Re: North Campus Facilities

Subj: Change Proposal No. 233901-0011

Williamson County – North Campus Facility

ASI #08 – 4/10/2017

2 SECTION - STAIR 1 - ELEVATOR
1/4" = 1'-0"

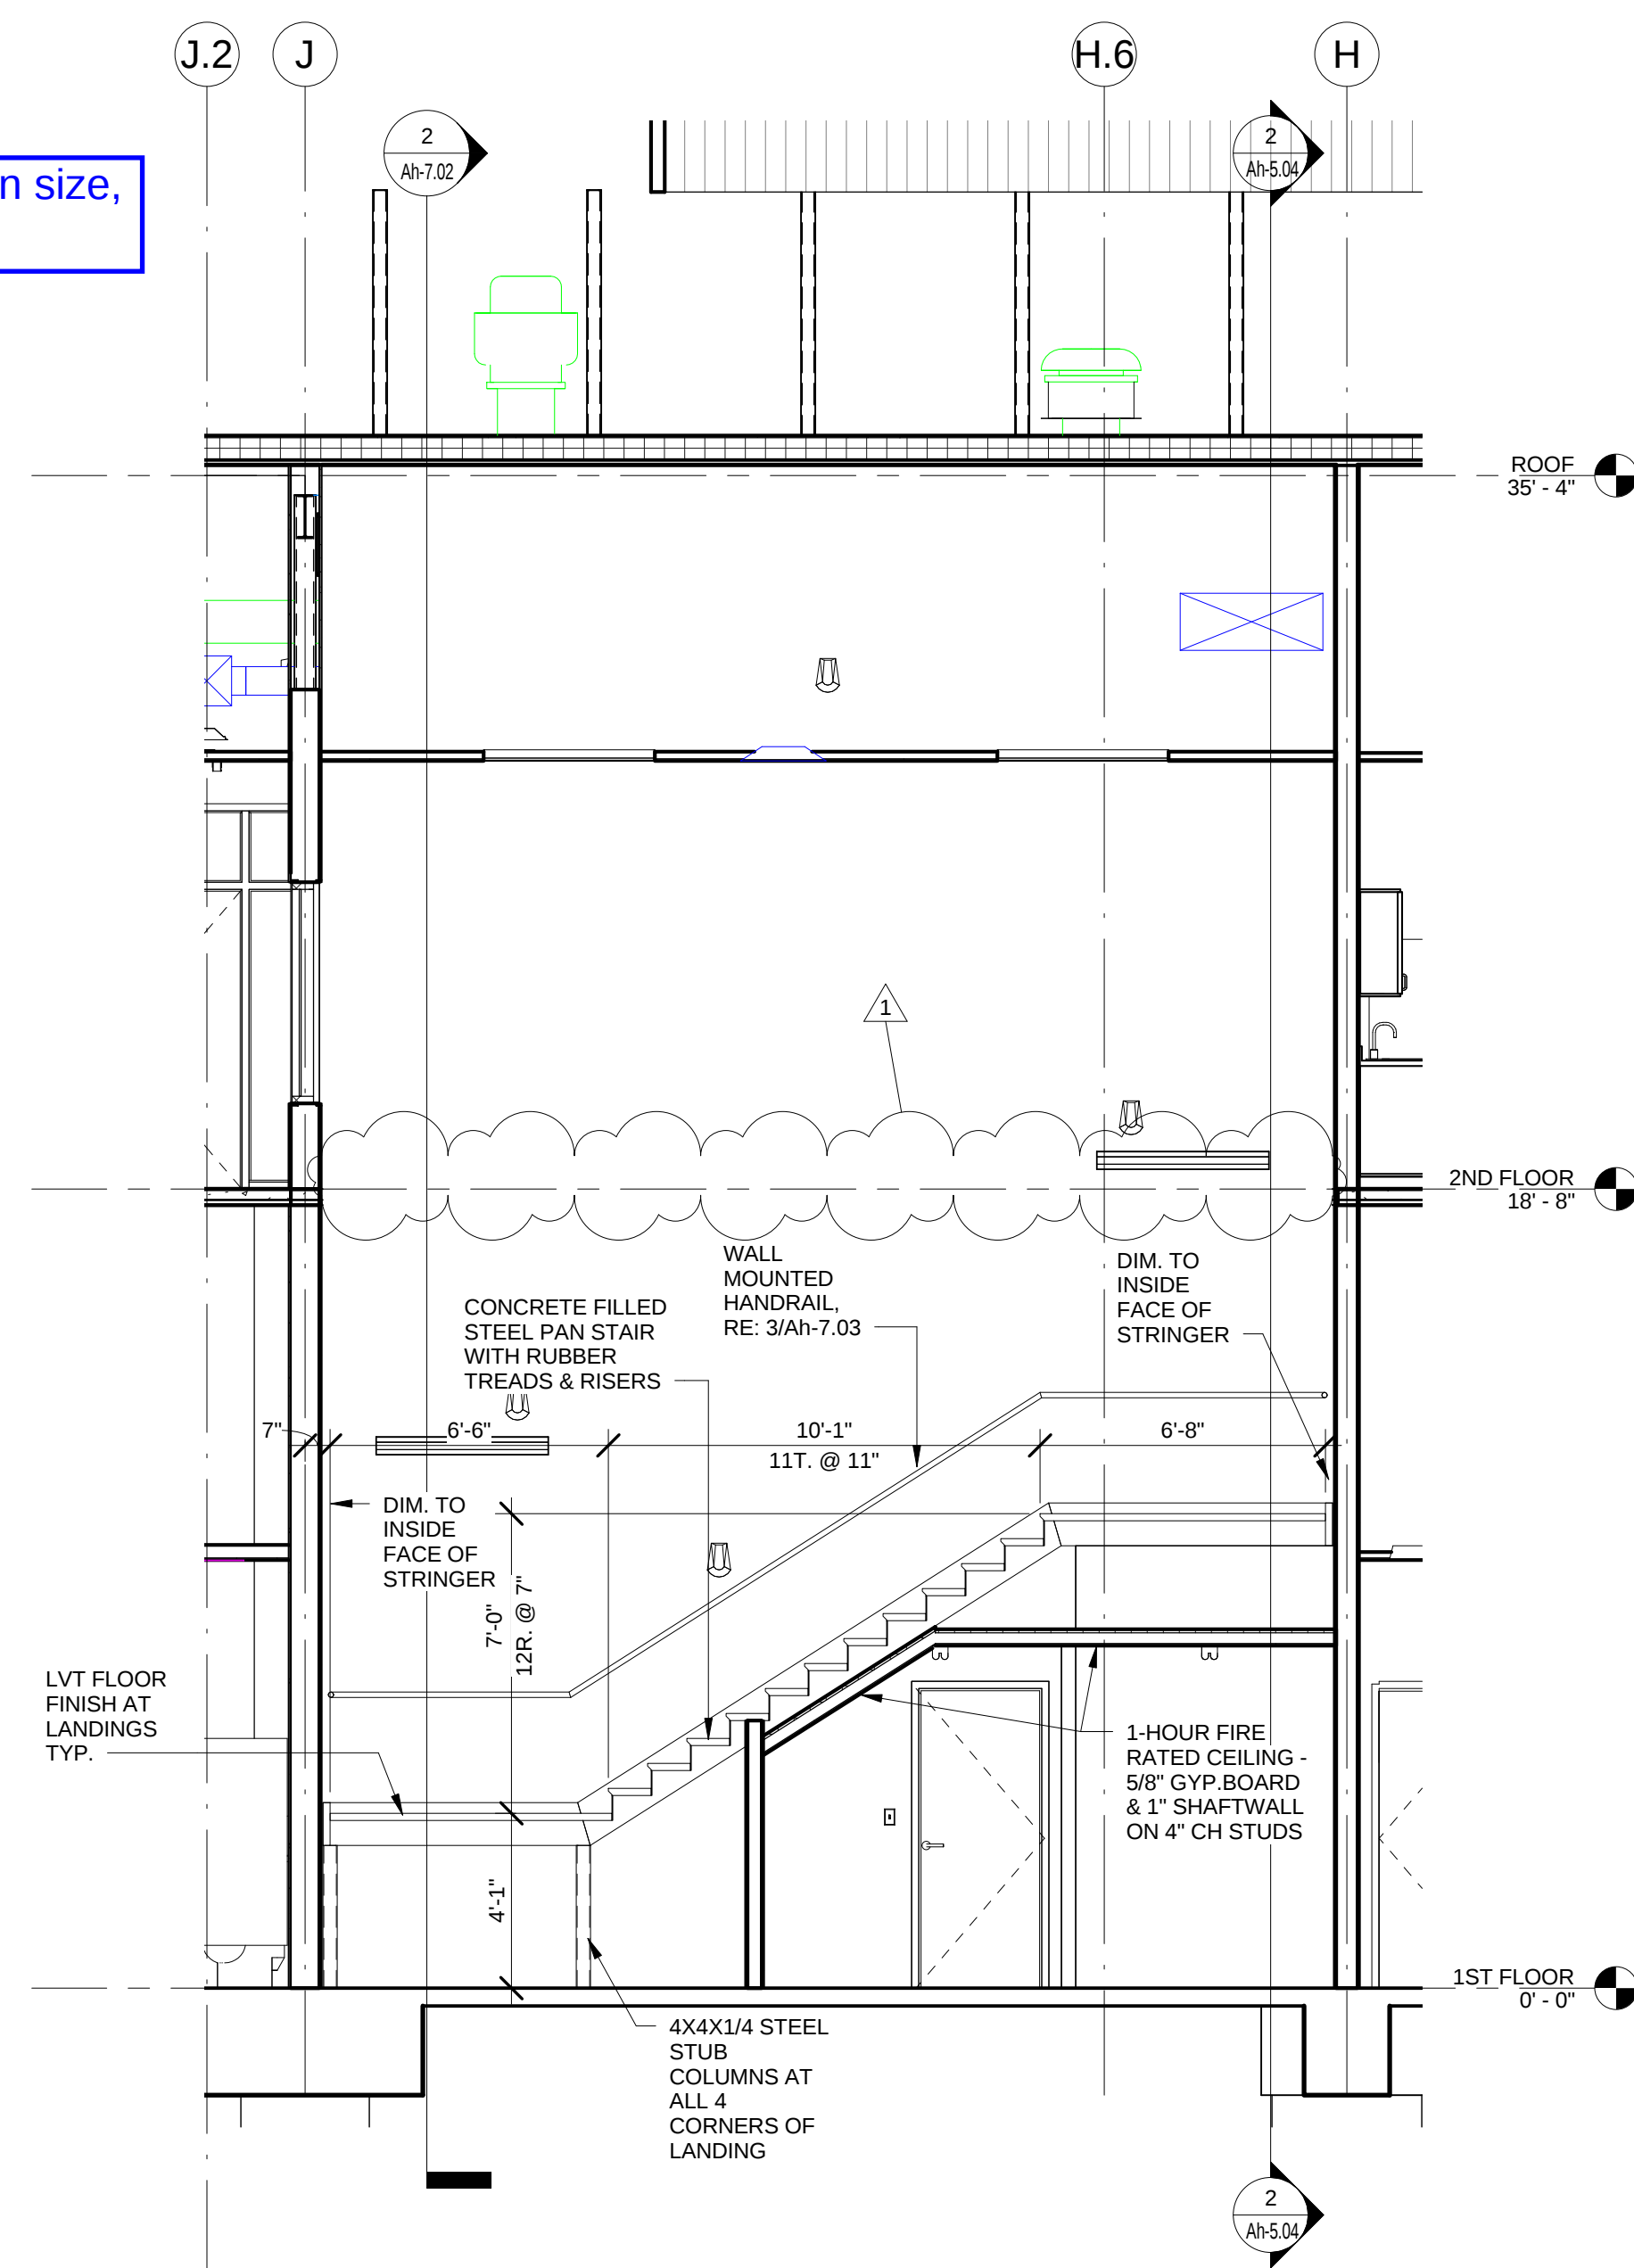
Please provide the hoist beam section size, location and connection details, as indicated in the attached sheet Ah-7.02.

Refer to attached details for structural steel posts and tube framing to support the hoist beam and to support the elevator guide rails as required by the elevator manufacturer.
